RE: BENNETTS GREEN BUNNINGS AND BULKY GOODS DEVELOPMENT

1. As requested, we are writing regarding matters raised by council and RMS in relation to the above development. We have previously prepared a report¹ which was submitted with the development application.
2. The council email of 27 September and RMS letters of 26 October 2017 include a number of traffic and parking matters. In response to the matters raised, amended plans have been prepared by the project architect. These matters, and our responses, are set out below.

188°17'35"

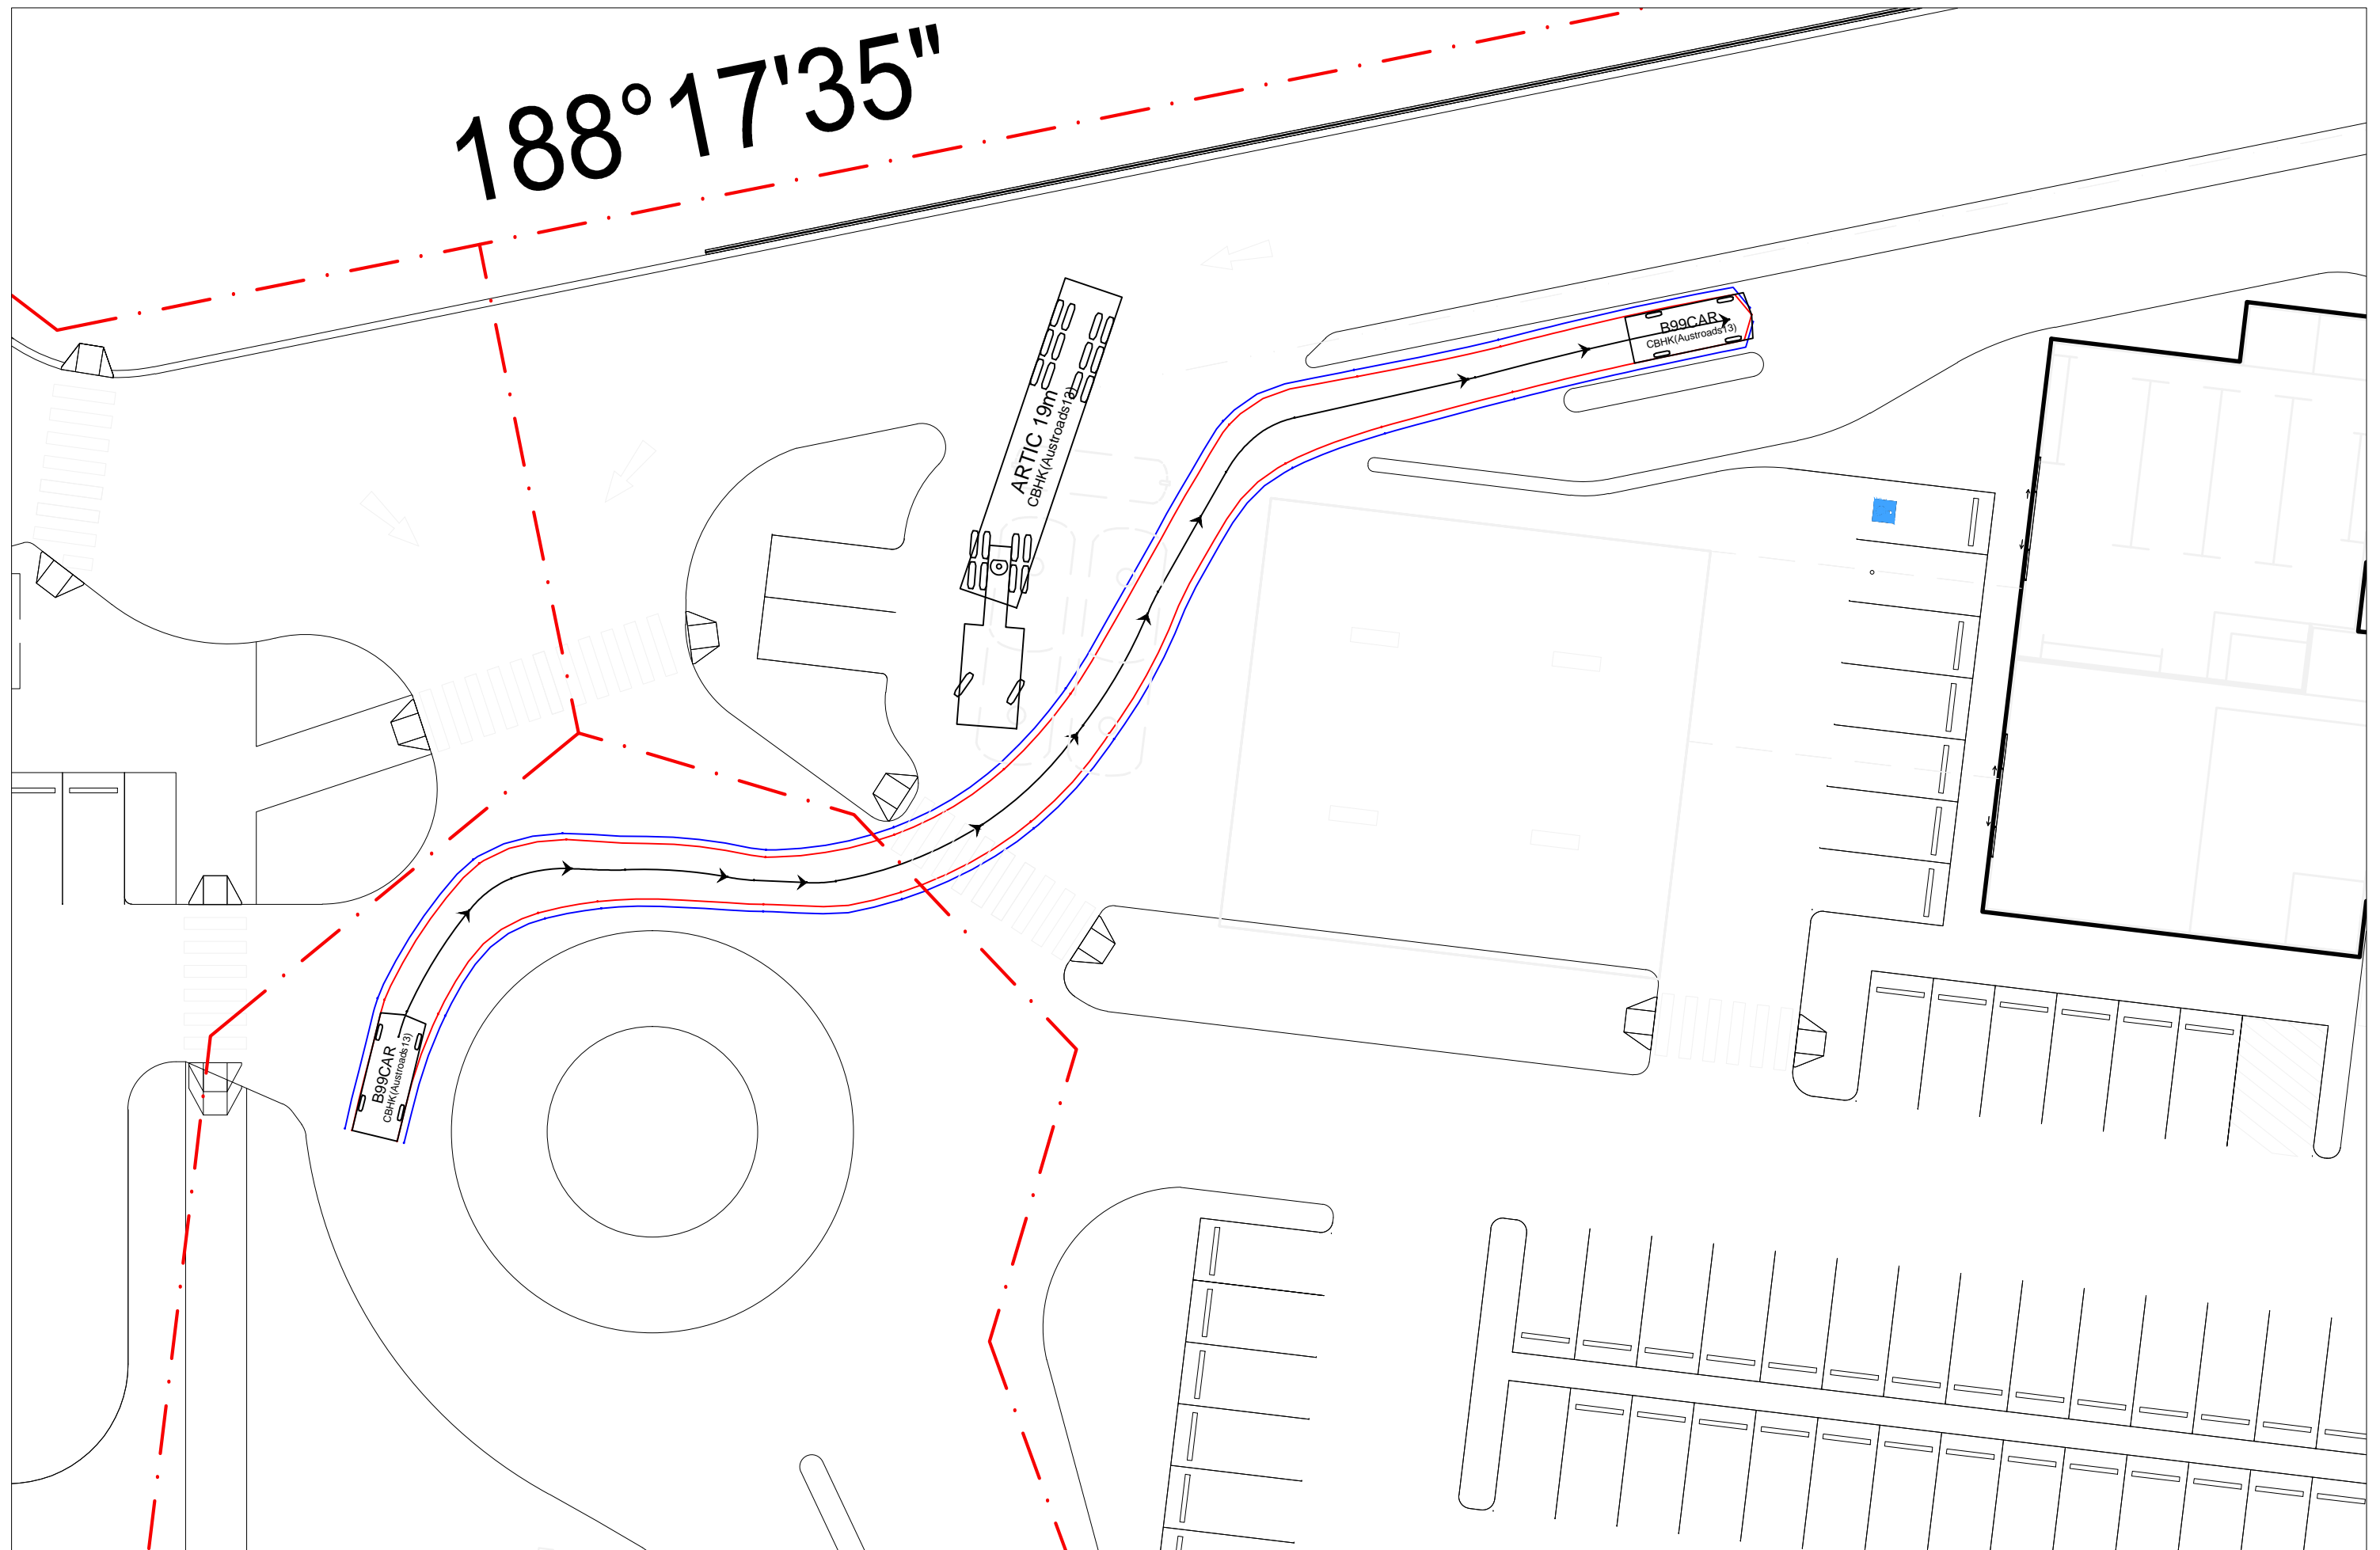
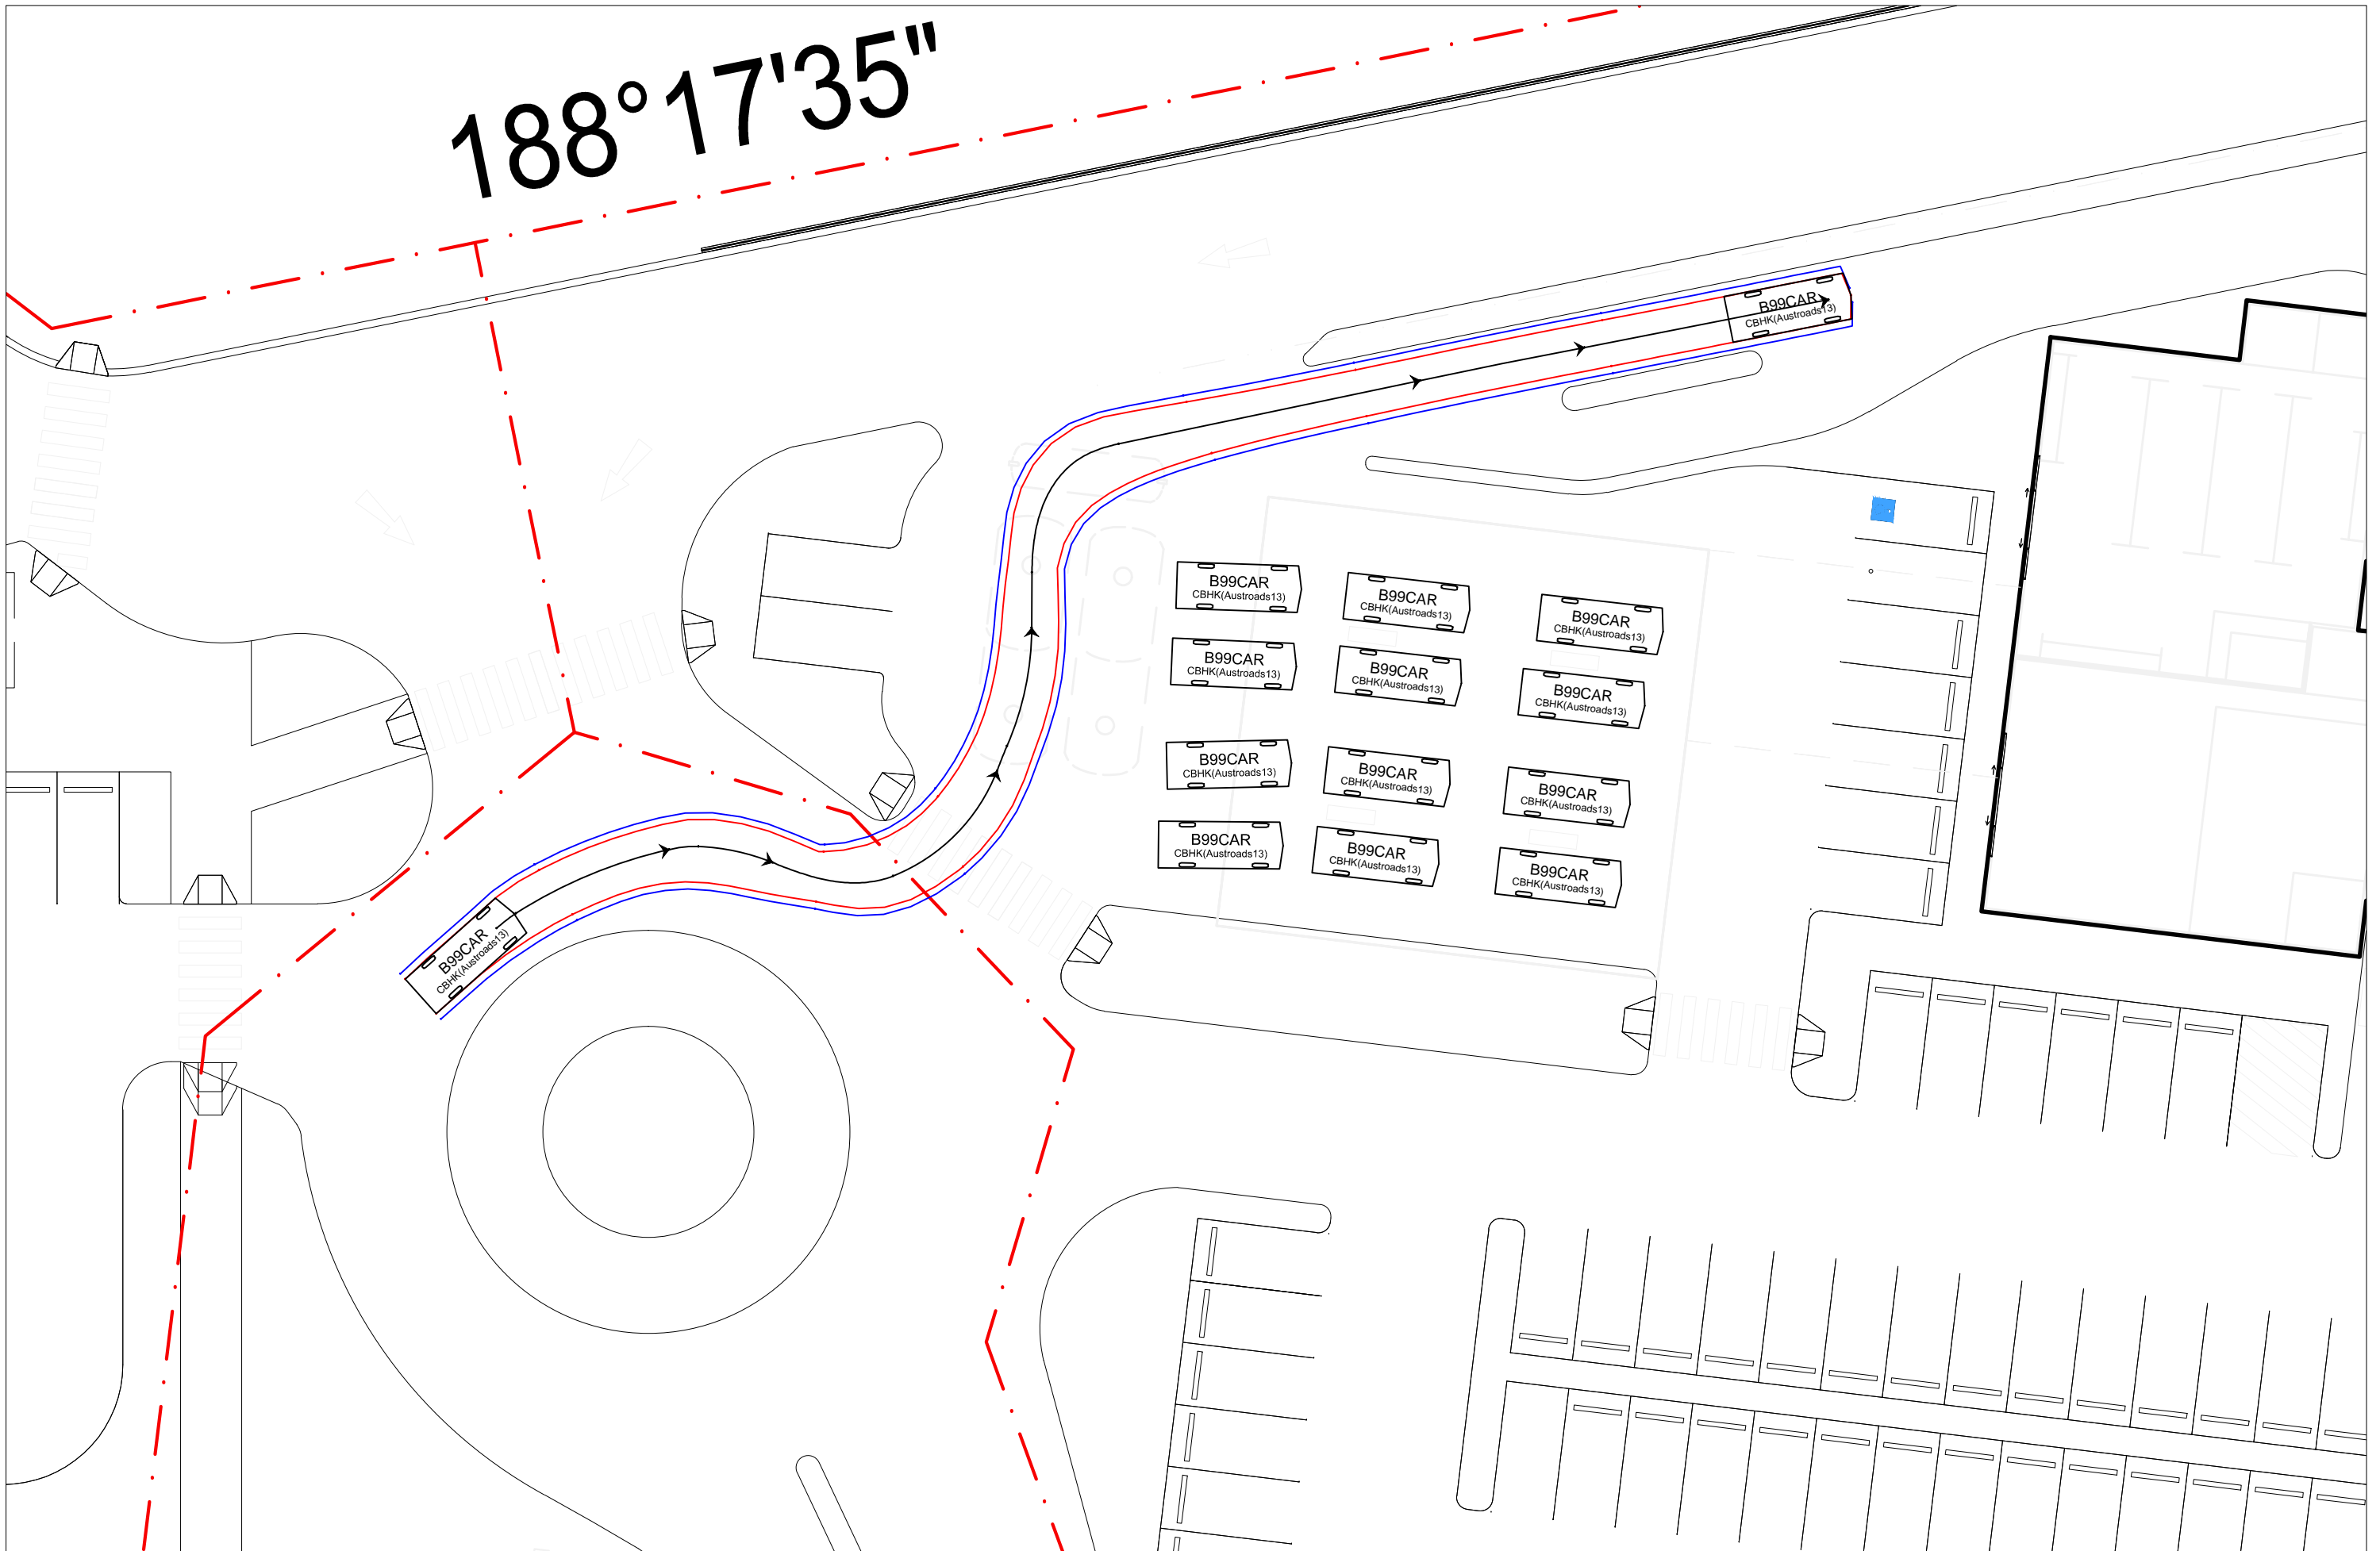
6. The proposed arrangements are therefore considered to be appropriate.
 - *Building Products Warehouse and Showroom*
 - 1) *The access ramp/driveway from South Street to the rear service bay of the Building Products Warehouse and Showroom requires additional detail in the form of widths, clearances and the like, inclusive of swept paths from South Street, through the access ramp and within the service delivery bay...*

- *Servicing*
 - 1) *Details of service vehicles including swept paths are required for internal areas (deliveries and waste collection) for the Building Products Warehouse & Showroom as well as the Bulky Goods Units and Restaurant. Additionally movements at the (Bunnings service vehicles) South Street and the Pacific Highway access points are to be provided.*

- *Details for servicing (deliveries & waste collection) the development are required in terms of manoeuvring/swept paths.*

7. Vehicle swept paths are attached to this letter as Figures 1 to 12.
 - *Parking*
 - 1) *The development provides a total 846 car parking spaces, 13 additional non-discriminatory parking spaces and 2 waiting bays. An assessment based on the proposed GFA identified 697 car parking spaces and 14 non-discriminatory parking spaces as being required. Therefore as an excess in car parking is proposed a reduction is required as per Council's DCP and to improve landscaped outcomes.*

21. Service vehicle swept paths are shown in Figures 1 to 12.

- *The plans are ambiguous as to how vehicles will access the Take Away Food & Drink Premises. It appears vehicles are required to access the drive thru via the entrance of the Service Station, which could become quite congested considering queuing for petrol bowsers. Details are required on how vehicles will access the drive thru and what will prohibit these vehicles travelling on the Service Road in the opposite direction to Service Vehicles.*

16. Vehicles will enter this drive-through from the service station, in a similar manner to many other service station/fast food developments. The swept paths attached in Figure 12 show that with two vehicles queued at the petrol bowers, other vehicles will be able to readily circulate to the drive-through.
17. There will be appropriate no entry signage at the western leg of the roundabout, which will apply to service vehicles and general traffic.

Existing weekday afternoon peak hour traffic flows plus development traffic

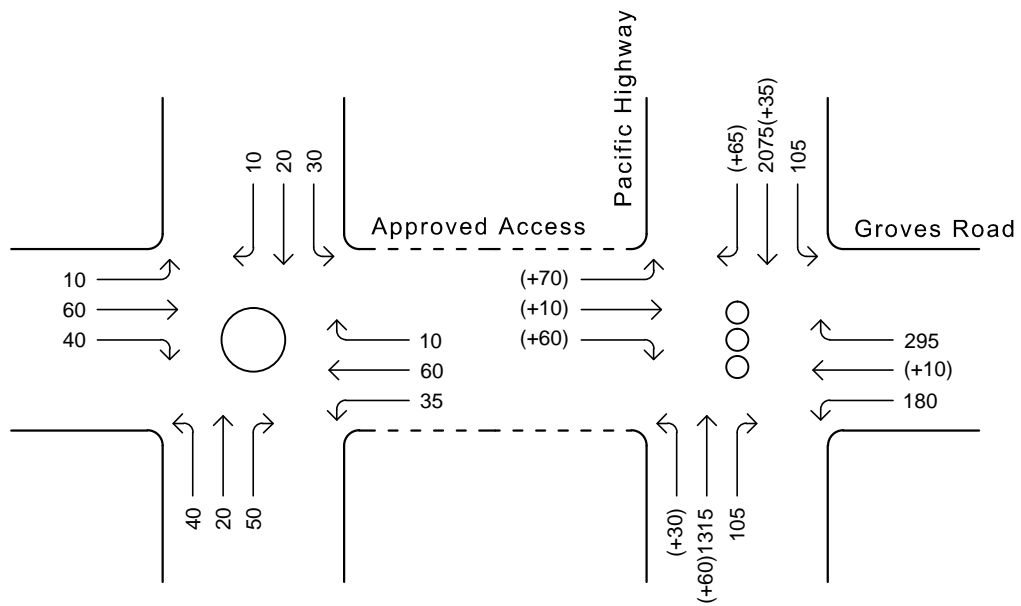
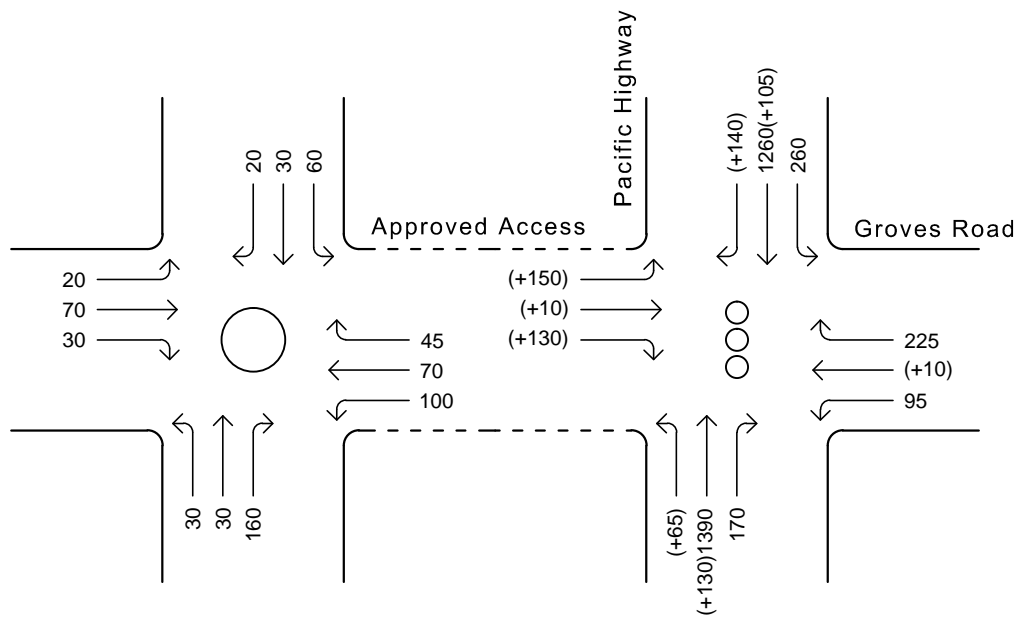
- *Traffic Counts should be included in the Traffic Report and the electronic copy of the traffic model should be submitted to RMS for review. Updated traffic counts at the intersection of Pacific Highway / Groves Road for weekday AM, Thursday PM and Saturday AM peak should be undertaken to inform the traffic modelling.*

23. We have undertaken updated traffic counts at the intersection of Pacific Highway with Groves Road for weekday afternoon and Saturday lunchtime periods. The results of the surveys are shown in Figures 14 and 15, and summarised in Table 2.

25. Additional development traffic flows through the Pacific Highway/Groves Road intersection, and through the internal roundabout intersection, are also shown in Figures 14 and 15.
